**Monitoring Report
Year 5
FINAL**

Little Buffalo Creek Stream Mitigation Project

*NCDEQ-DMS Project Number: 94147
Contract Number: 2029
USACE Permit Action ID: 2014-00386
DWR Permit: 14-0129
Cabarrus County*

Subject: DRAFT Monitoring Year 5 report for the
Little Buffalo Creek Stream Mitigation Project
Yadkin River Basin – CU# 03040105– Cabarrus County
DMS Project ID No. 94147
Contract # 002029

Supplemental Planting Location Exhibits

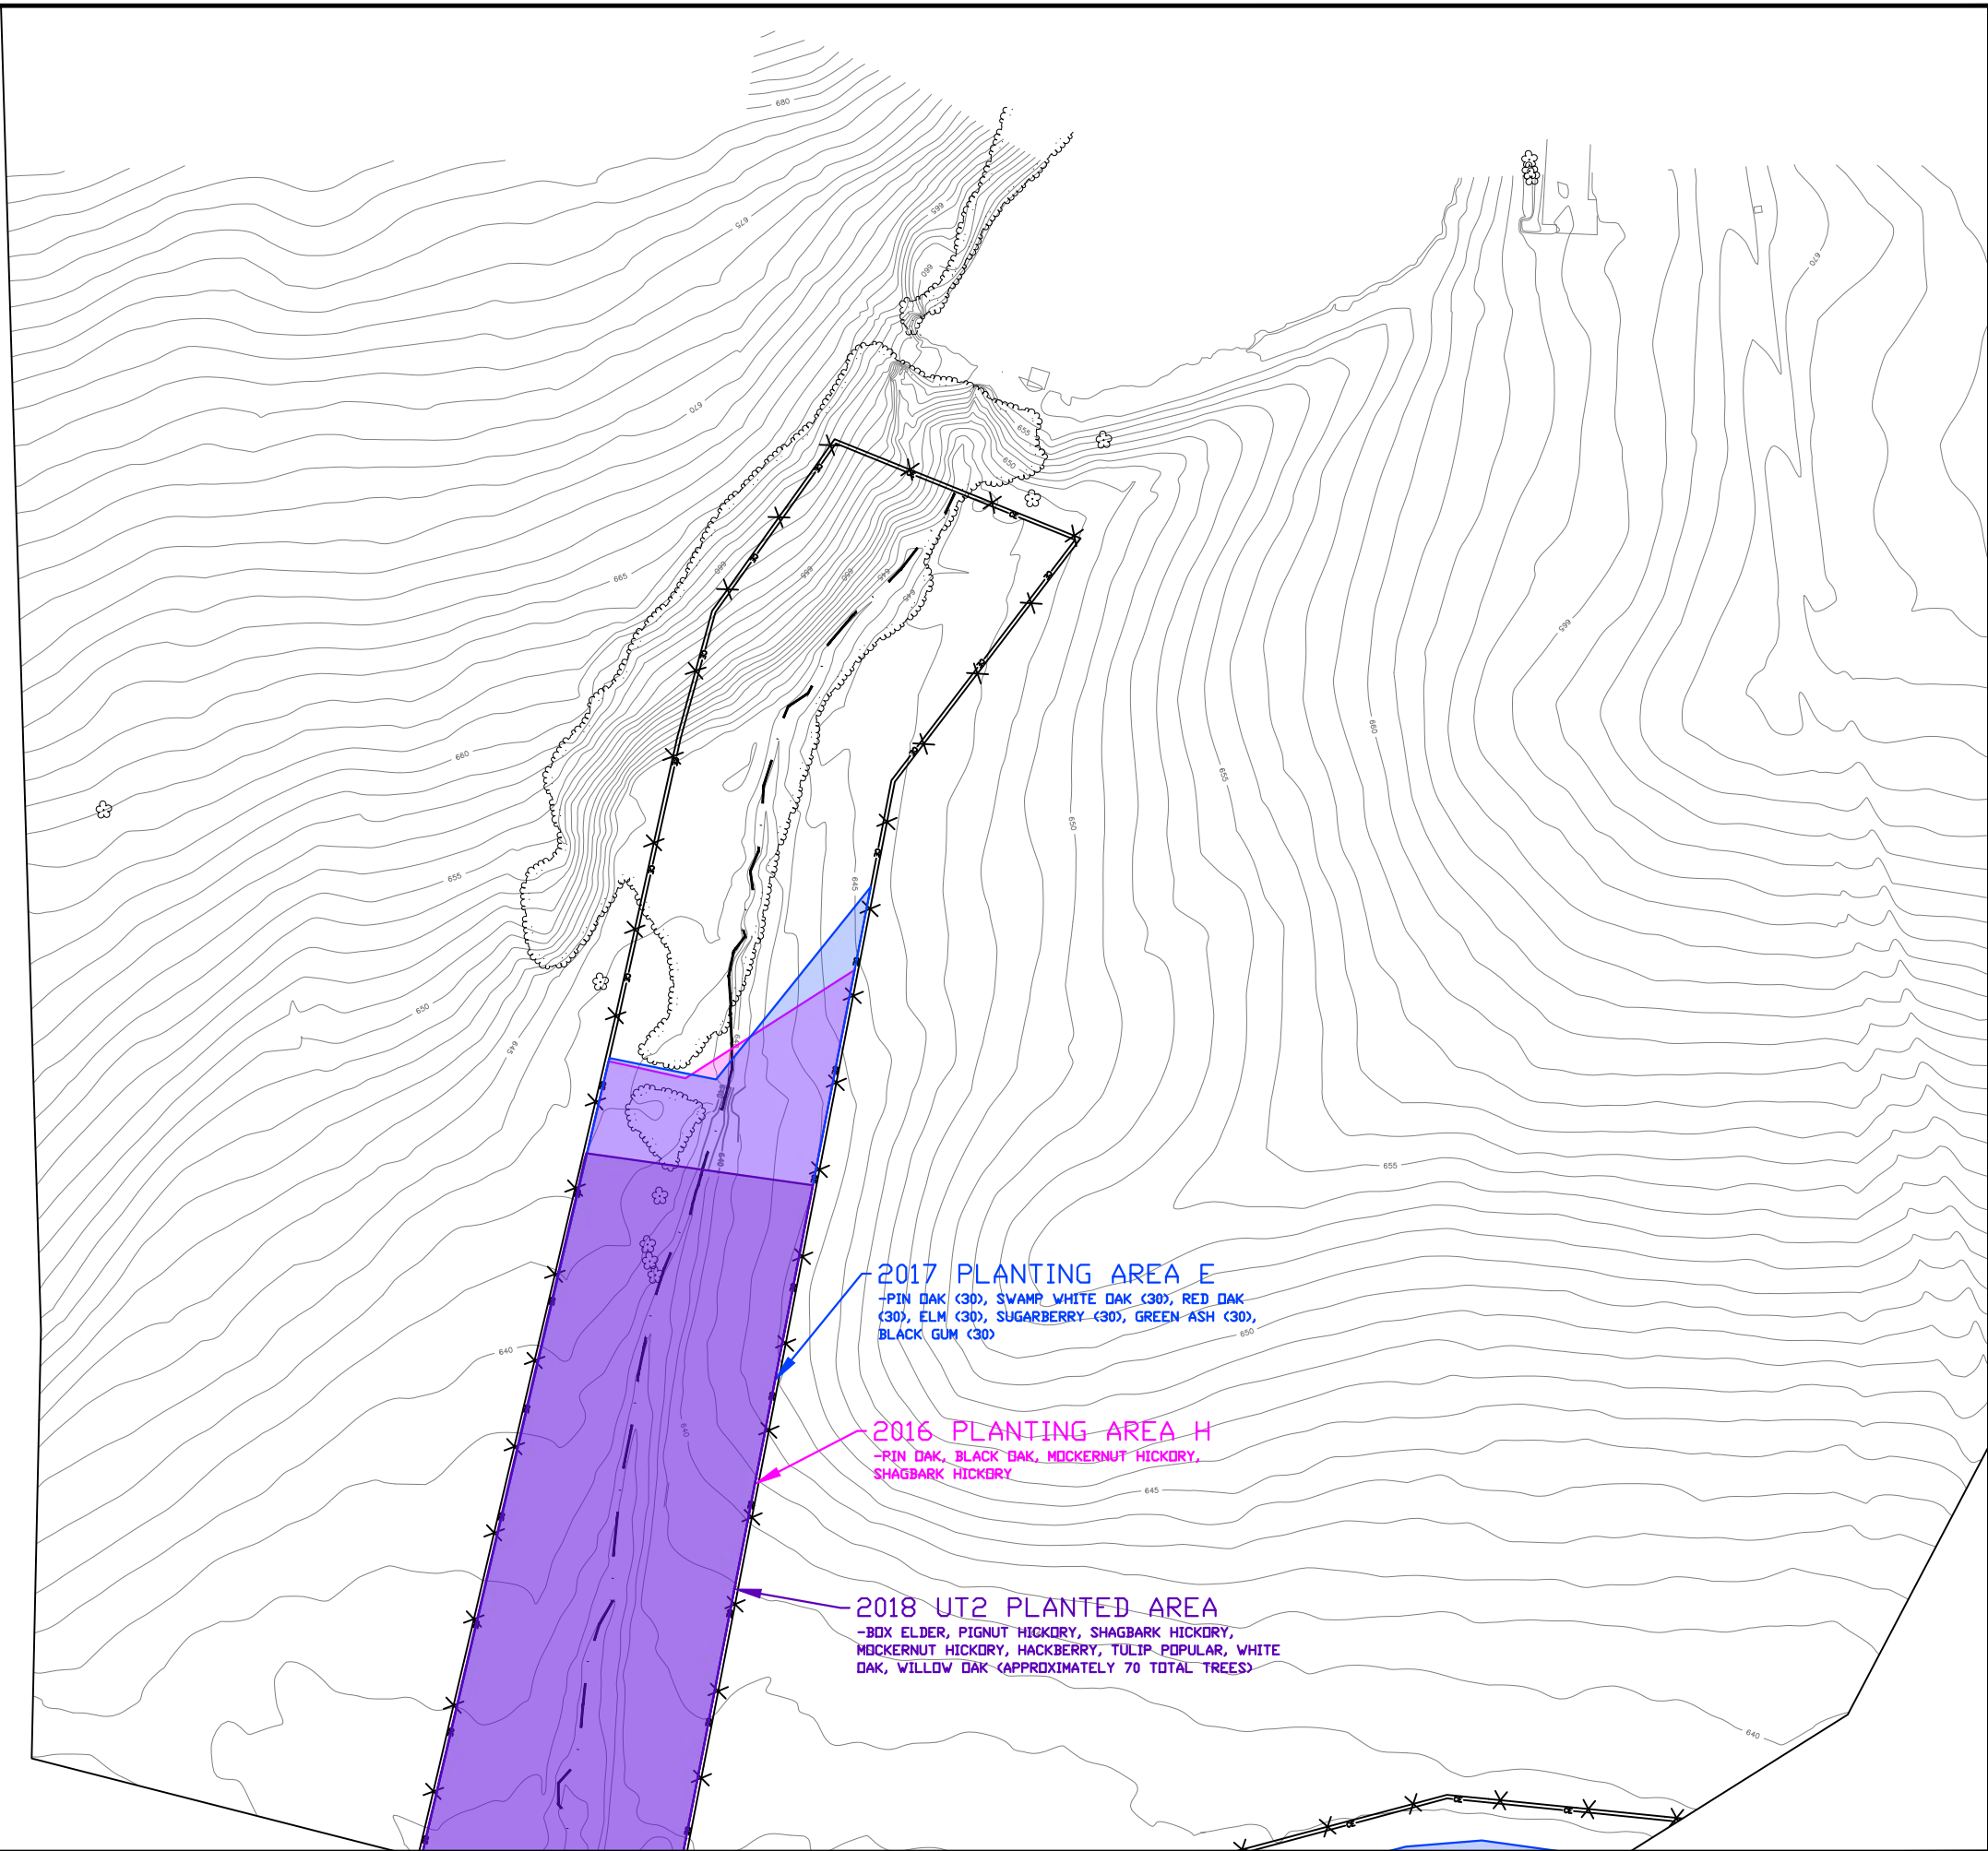
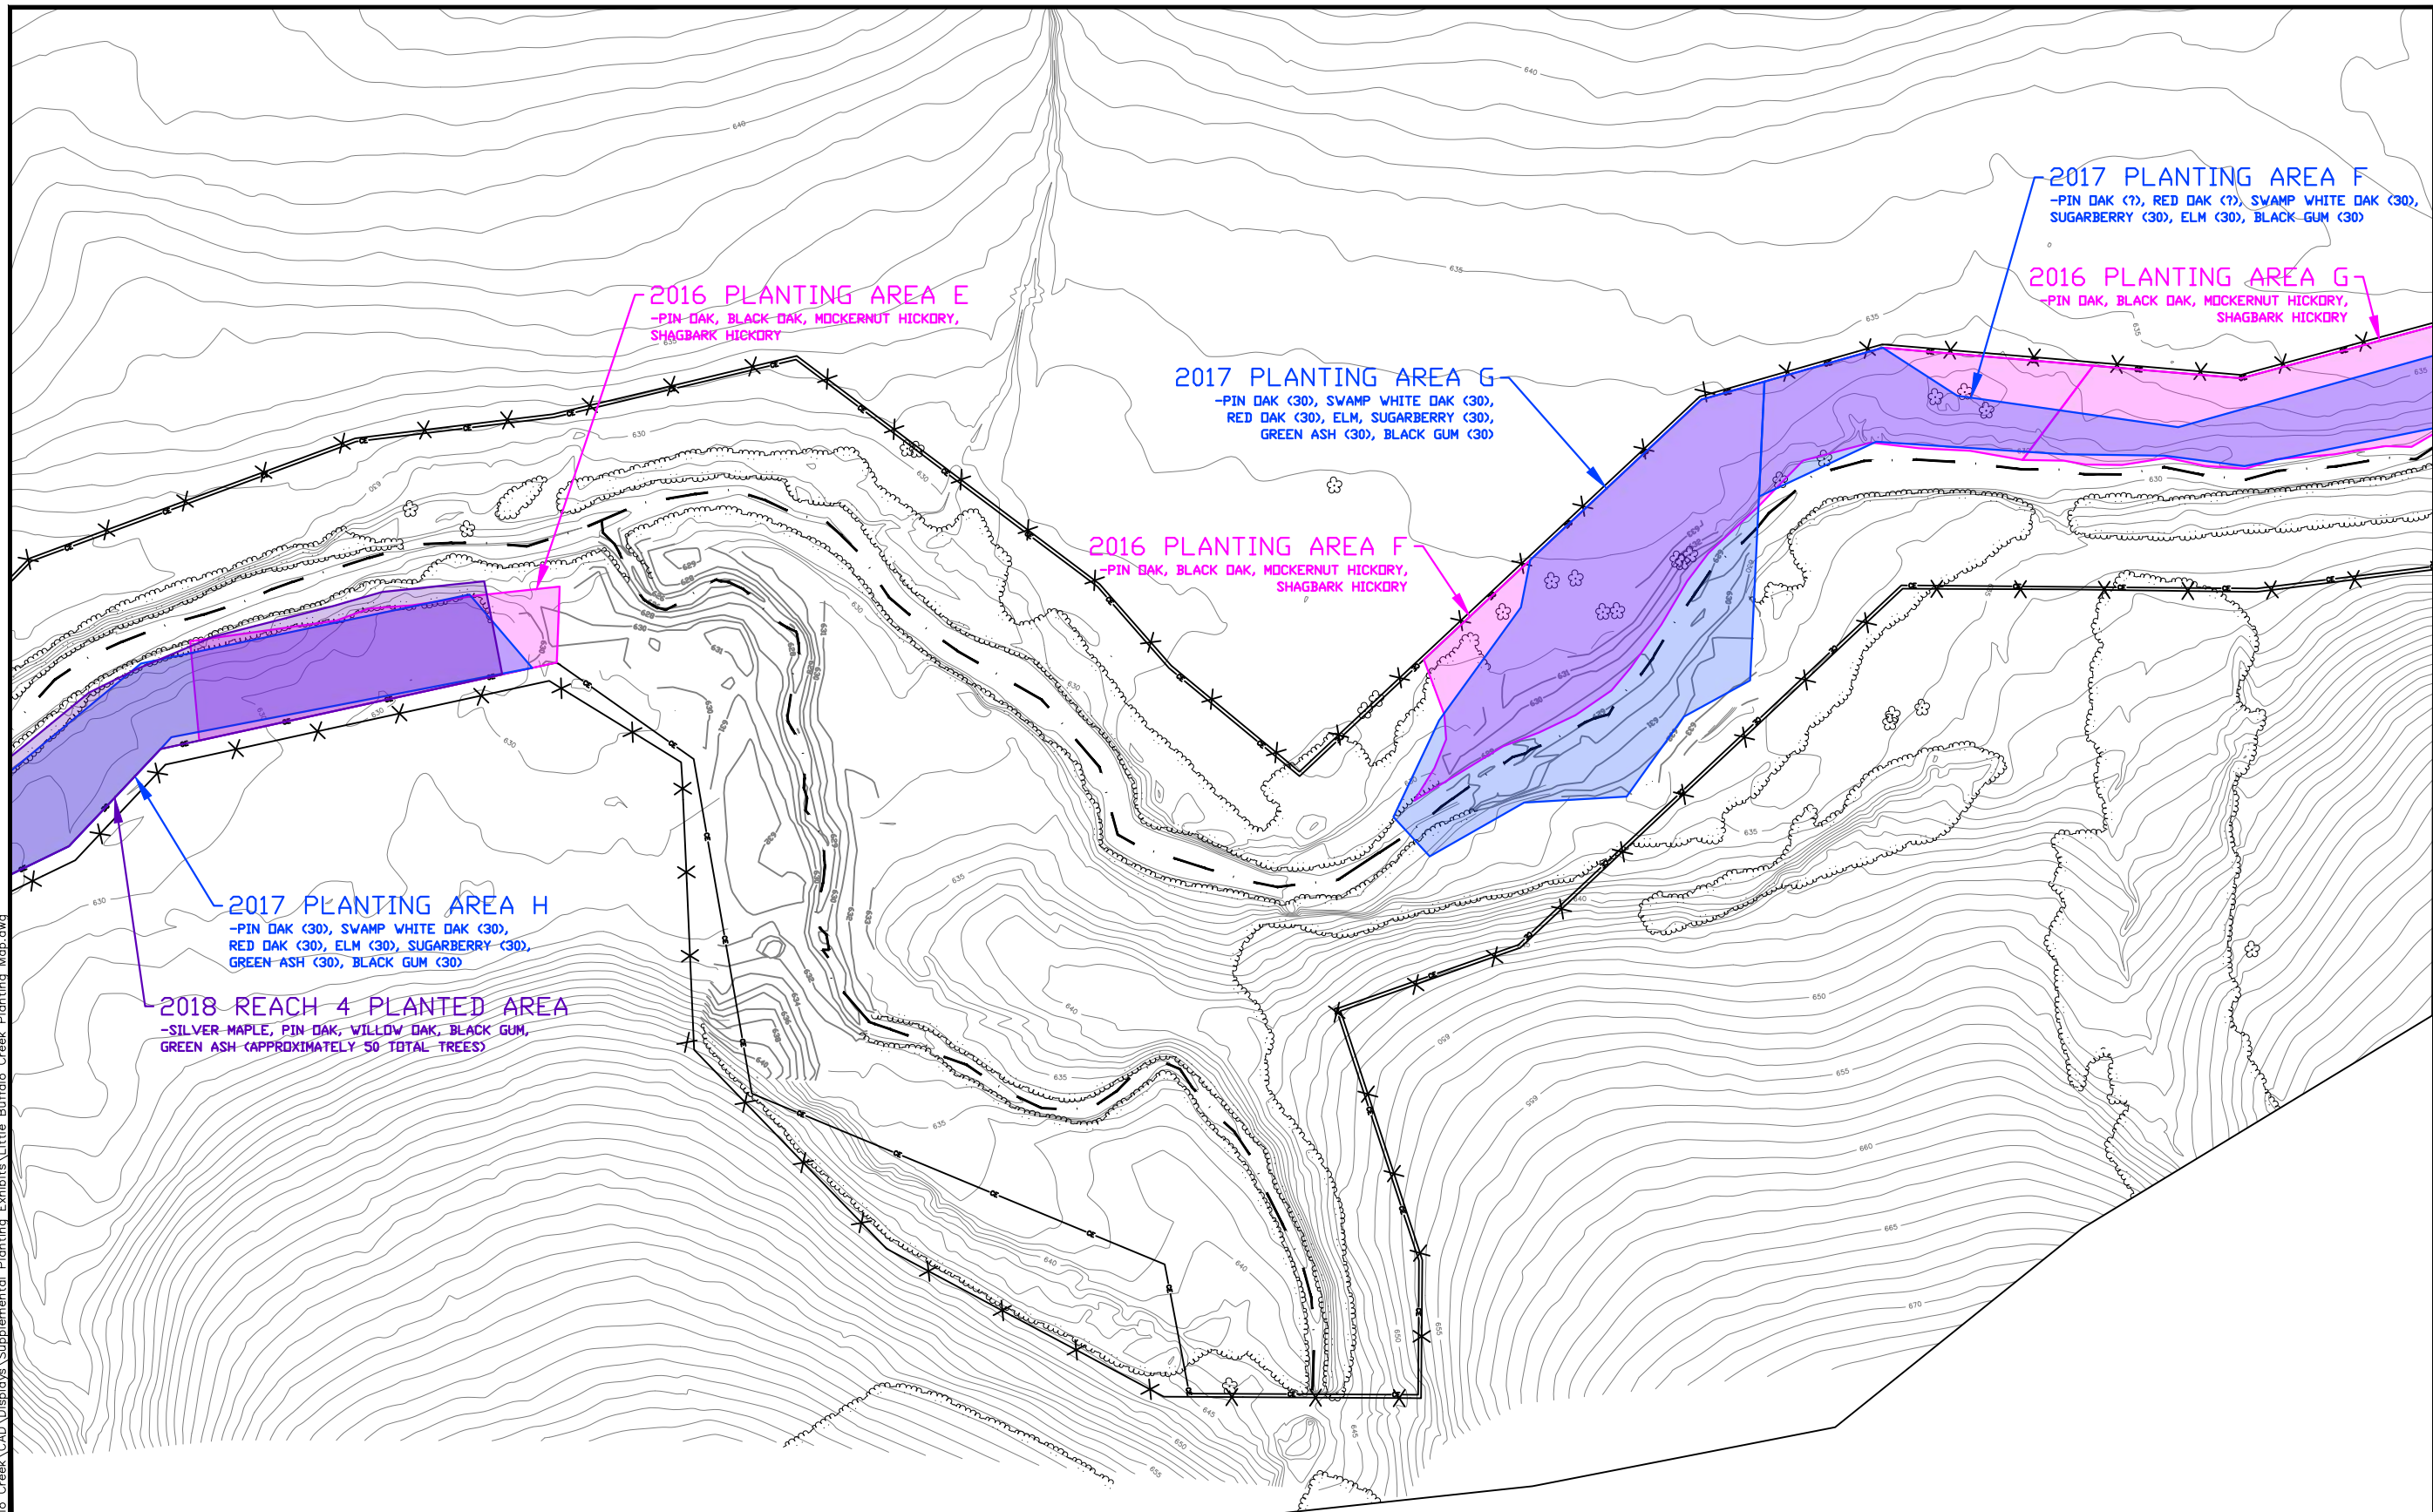
Section 1.5.1.3 - Volunteer Species (Supplemental Plantings): Please describe the placement of the supplemental plantings relative to the vegetation plots and non-plot areas. A supplemental planting map (with planting dates) would be helpful and at a minimum should be provided in the project closeout report.

- *WSP added text in section "1.5.1.6 Additional Tree Planting" of the Monitoring Year 5 report that describes locations of supplemental plantings from February 2016, March 2017, and November 2018. A map depicting these planting locations and dates has been included in Appendix F. This map will also be included in the project closeout report.*
